Iowa Department of Transportation

MINUTES OF IOWA DOT SPECIFICATION COMMITTEE MEETING

September 8, 2005

Figure 1
Clothing and equipment for daytime flagging operations

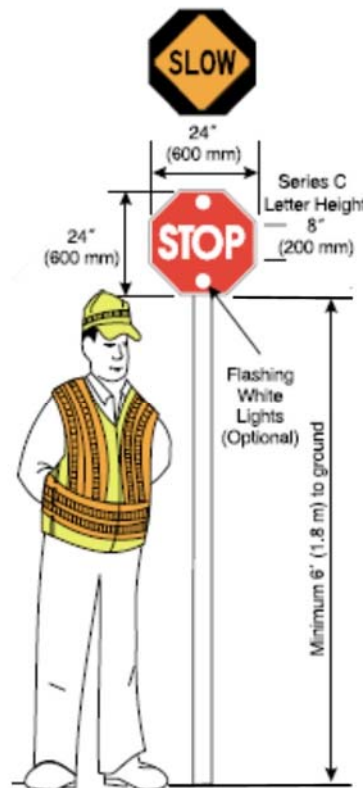
In addition to being dressed neatly, flaggers need to be dressed for safety. In particular, flaggers are required to be easily visible to traffic. **Flagger's shall Always** wear the following required items, even when serving as a replacement for a short period (see Figure 1):

- an ANSI 107-2004 Class 2 vest, shirt, or jacket in yellow green, or orange, or fluorescent versions of these colors (combinations of these colors are acceptable) and
- a soft cap in yellow green, or orange, or fluorescent versions of these colors meeting ANSI 107-2004 headwear requirements; combinations of these colors are acceptable. (A hard hat in the same colors is an acceptable alternative to the soft cap and may be required by OSHA or your employer in certain circumstances.)

Flaggers shall be equipped with the standard combination STOP/SLOW or SLOW/SLOW staff-mounted sign (see Figure 1). Retroreflective sheeting shall comply with applicable specifications.

(New image)

Figure 10
Clothing and equipment for nighttime flagging operations

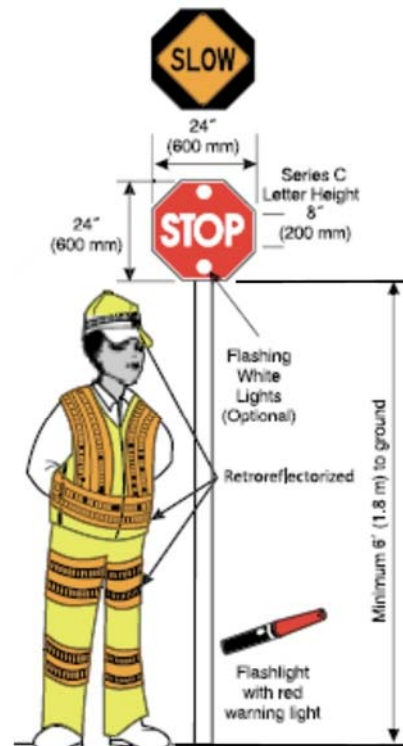
When flagging at night, **Flagger's shall** wear the following required items (see Figure 10):

- an **ANSI 107-2004 Class 2** retroreflectorized vest, shirt, or jacket and **ANSI 107-2004 Class E** retroreflectorized pants in yellow green, or orange, or fluorescent versions of these colors (combinations of these colors are acceptable), and

- a retroreflectorized soft cap in yellow green, or orange, or fluorescent versions of these colors meeting **ANSI 107-2004 headwear requirements**; combinations of these colors are acceptable. A retroreflectorized hard hat in the same colors is an acceptable alternative to the soft cap and may be required by OSHA or your employer in certain circumstances.

At night, flaggers shall be equipped with the following (see Figure 10):

- retroreflectorized signs and other devices (retroreflective sheeting shall comply with applicable specifications),
- flashlight with nose cone, lantern, or other lighted signal that will display a red warning light, and
- a lighted flagging station (see Figure 11).

(New image)
